Appendix F

Economic Model

**Draft Evaluation of the Cape Wind Energy Project Proposed Site and Alternatives
With the Offshore Wind Energy Project (OWEP) Model;
A Microsoft Excel Cash Flow Spreadsheet**

Response to Peer Review Comments

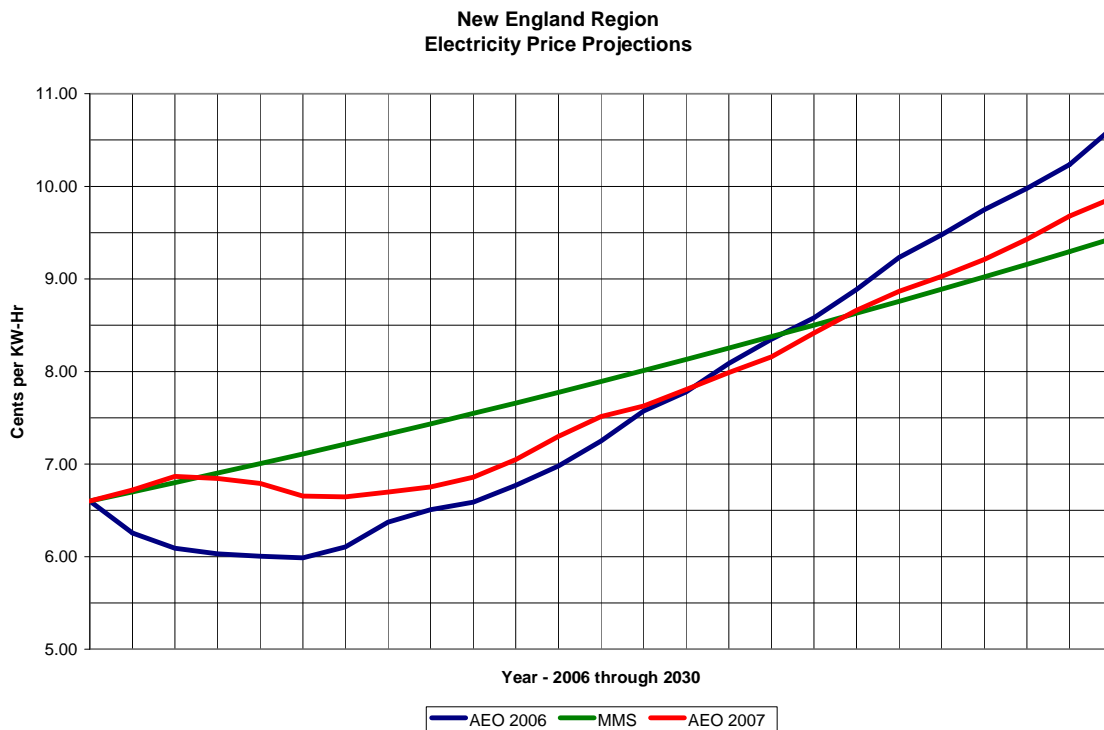
- The formula described on page 8 has an error; it does not equal 5.24% as stated in the example.
 - This formula is not the correct formula for calculating the weighted average cost of capital (WACC). The WACC cannot be lower than the cost of either source of capital alone. It appears that the formula is attempting to calculate a *real* WACC (e.g. backing out inflation), but the entire analysis is conducted on a nominal basis with nominal dollars, and therefore a real calculation does not appear appropriate.

- The formula described on page 8 is a constant rate; the formula appearing in each sheet of the model differs for each project.
 - The formula described on page 8 is not the one used in the model in cell M2, as indicated.

- The document describes an application of the same discount rate, at a constant WACC, to each project. In the model, however, cell M2 is not a calculation or the same discount rather a different discount rate imputed to yield a zero (or slightly positive) figure in cell N27. The model is discounting the cash flows (using what

Prior to beginning the economic analysis, MMS considered the possibility that the project might not produce a positive net present value under existing economic conditions. Anecdotal cost information from offshore wind energy projects in Europe indicated that capital costs had risen significantly since the Cape Wind Energy Project was first proposed. To investigate, a preliminary evaluation of the proposed site was conducted, using a discount rate derived with the simplified WACC formula given in the peer review report. The formula calculates an approximation of the real, rather than nominal, WACC. The real WACC was calculated because nominal cash flows in the spreadsheet are deflated before discounting. The WACC formula did contain a typographical error in the peer review report; an extra set of parenthesis appeared in the denominator. The formula should have appeared as: $((1 + 0.07*0.75 + 0.105*0.25)/(1 + 0.025) - 1)*100\% = 5.24\%$.

A negative cumulative net present value was calculated for the preliminary evaluation. More attention was not given to the discount rate determination in the peer review report, because the net present value and internal rate of return values were not used to rank the projects.

An explanation of the values entered in cell M2 of the spreadsheet, in lieu of the discount rate described in the first paragraph of this response, was not given in the discount rate section on page 8 of the peer review report. Instead, the intended meaning of these values was explained in the last two sentences of the fourth paragraph in the narrative under “Materials and Methods” on page 5. It was explained that: “The rates of return for the proposed site and the alternatives were calculated by iteratively adjusting the discount rate in row 2 of column M, until the cumulative cash flow was reduced to a value close to \$0. Rate of return values are reported on the worksheet tabs within the spreadsheet.” Attaching the generic label of “rate of return” to the value in M2 was not appropriate, and improperly implied that the real internal rate of return could be calculated from nominal cash flows that had been discounted and deflated. This calculation gives a false result and should be disregarded, because debt service is not subject to inflation and tax depreciation is based on the original cost, which is not inflated. More discussion of this topic appears on pages 183 and 184 of Principles of Project Finance by E. R. Yescombe, Academic Press, 2002. The correct calculation of the nominal internal rate of return was made in cell L29, although the cell was not labeled. The label “nominal internal rate of return” should have been added in cell K29 of the spreadsheet to clarify this point.
